**Date:** February 12, 2024  
**To:** CLFLWD Board of Managers  
**From:** Mike Kinney, District Administrator  
**Subject:** Permit 23-031 - West Lake Commercial

<b>Project</b>   West Lake Commercial	<b>Date</b>   2-8-2024
<b>To</b>   Mike Kinney	<b>Contact Info</b>   CLFLWD
<b>Cc</b>   Board of Managers	<b>Contact Info</b>   CLFLWD
<b>From</b>   Greg D. Graske, P.E.	<b>Contact Info</b>   EOR
<b>Regarding</b>   Permit Application #23-031, City of Forest Lake

**Project Purpose:** The proposed project will construct a 9,600 SF building along with parking lot and landscaping improvements, resulting in approximately 0.9 acres of new and reconstructed impervious cover. The project will disturb approximately 1.3 acres on a 5.7 acres site.

WESTLAKE PREPARED FOR RIVERCREST REALTY INVESTORS FOREST LAKE, MN		<b>GRADING AND DRAINAGE PLAN</b>		KIMLEY HORN 2023 KIMLEY HORN AND ASSOCIATES, INC. 187 ELIXIR STREET, SUITE 100, ST. PAUL, MN 55114 PHONE: 612.644.4187 WWW.KIMLEY-HORN.COM	
---	--	----------------------------------	--	--	--

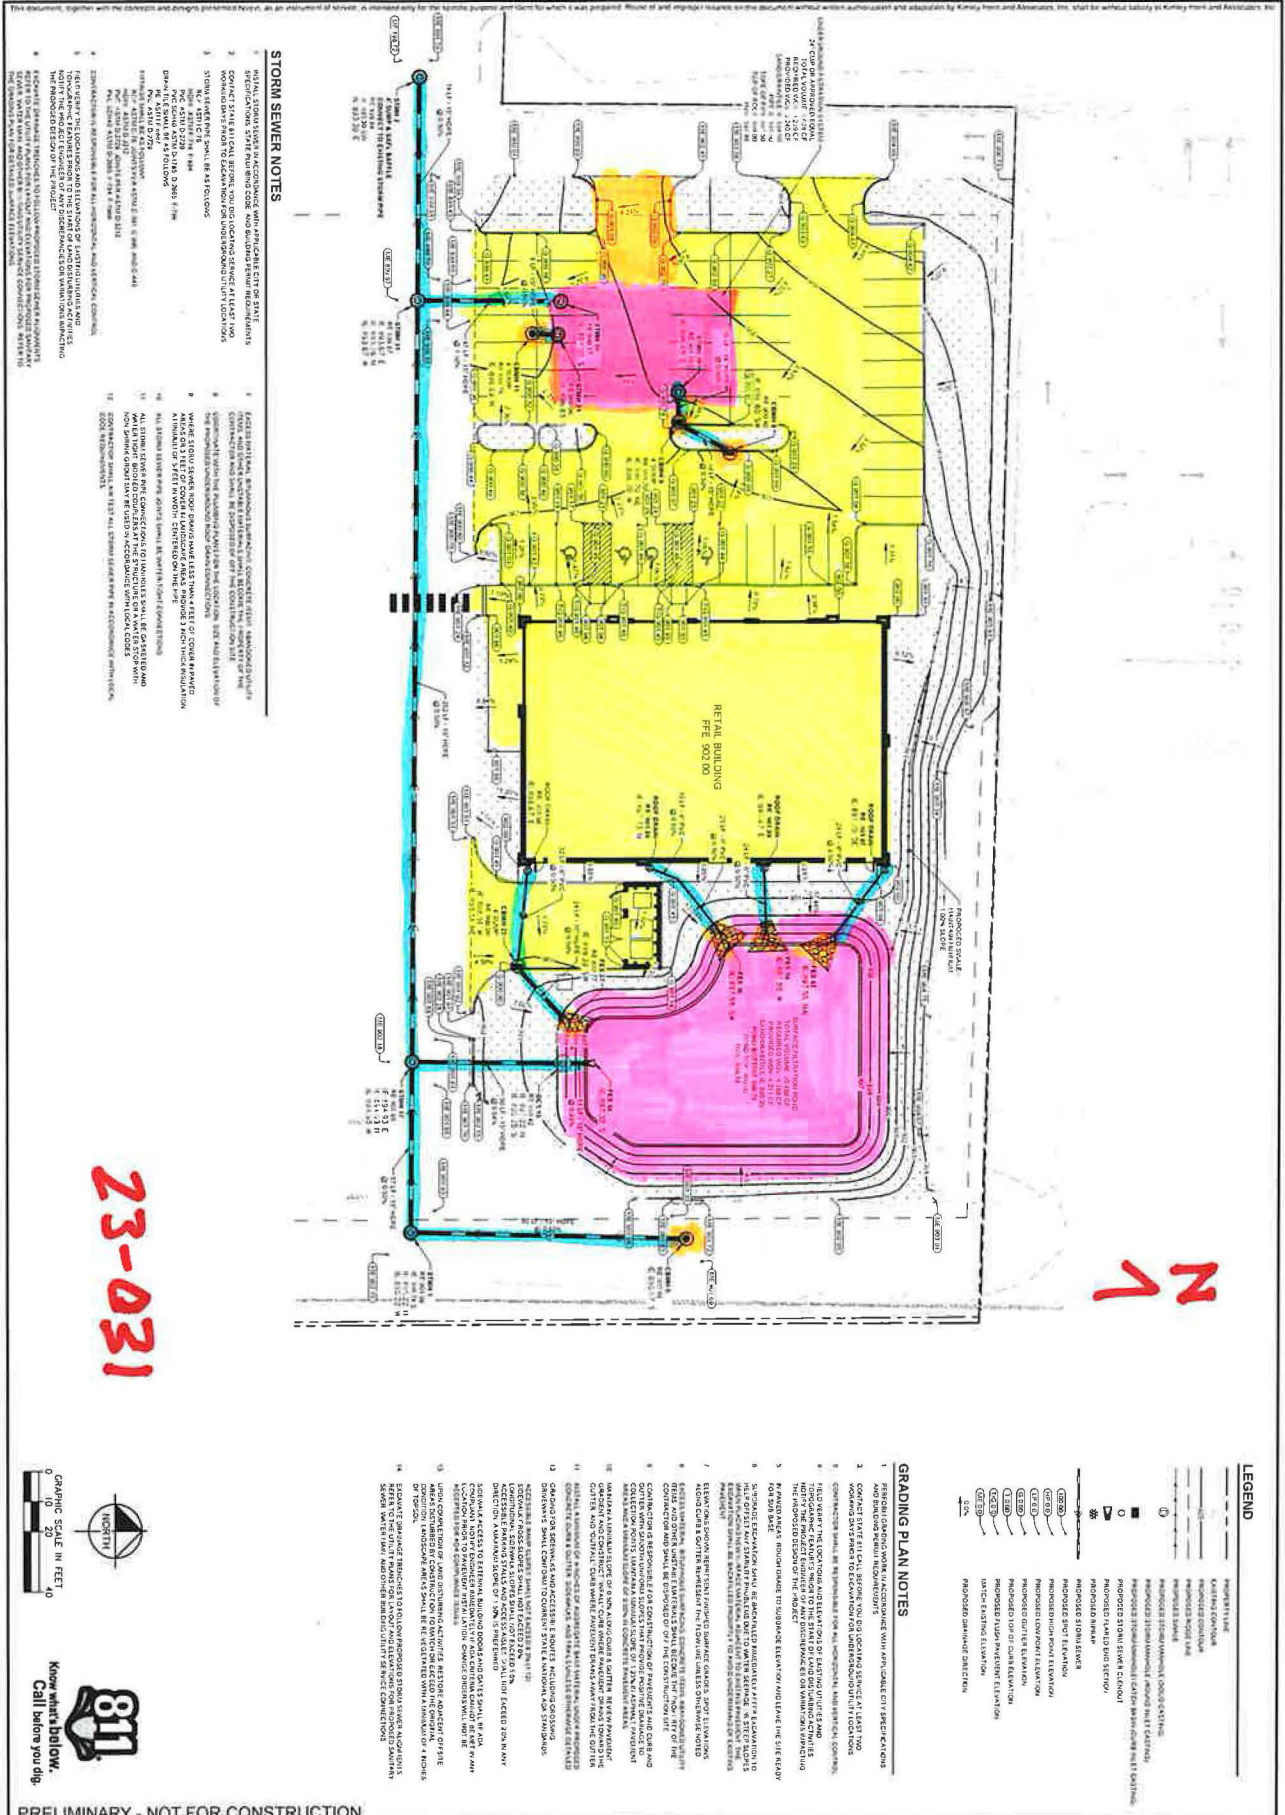
Under existing conditions, a stormwater pipe runs across the middle of the site. The project proposes to reroute this pipe around the site. To do this, a narrow corridor of existing pavement will have to be removed and reconstructed directly over the pipe. A small portion of the proposed new and reconstructed impervious cannot be captured by the proposed filtration features. Areas that are not captured by onsite BMPs must incorporate measures to capture suspended solids to the maximum extent practicable. A 4-foot sump and corresponding SAFL Baffle has been placed at the downstream end of the rerouted stormwater pipe to capture sediment to the maximum extent possible for the areas not captured by the BMPs.

Construction details for the proposed underground and surface filtration features have been provided. The soil mix for the surface filtration feature has a mixture of 80% sand and 20% compost. The higher amounts of compost will have the potential to leach phosphorus. The soil mix must be adjusted to specify no more than 10% Grade 2 compost, OR a Mehlich III test must be performed demonstrating that the mix has less than 30 mg/Kg of phosphorus to minimize phosphorous leaching. An 80-10-10 mix of sand-compost-peat is recommended.

1. Revised soil mix for surface filtration feature to specify no more than 10% Grade 2 compost, OR a Mehlich III test must be performed demonstrating that the mix has less than 30 mg/Kg of phosphorus to minimize phosphorous leaching. An 80-10-10 mix of sand-compost-peat is recommended.
